Product Change Notification

1. ECR #: 205117
Notification #: 586

2. Date of Announcement: June 24, 2021

- STD ASP - null

4. Part #'s Affected

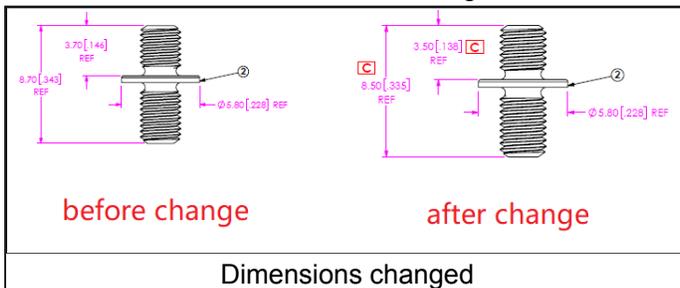
FRONT VIEW: CHANGE THE STUD LENGTH ABOVE LIFTING-SHOULDER FROM 3.70 REF TO 3.50 REF, CHANGE THE OVERAL LENGTH FROM 8.70 REF TO 8.50 REF.

To enable the customers to expand/share JSOM P/Ns in multiple applications including all VITA applications, where it was impossible before and streamline & simplify Samtec's Standard product offering, we improved the length of the stud above lifting-shoulder on the JSOM adjuster to 3.50mm. Customers will still be able to use the old revision materials in many demonstration or non-VITA applications. Advantage over the old revision materials, new revision materials will expand the component area limits to 3.50 mm.
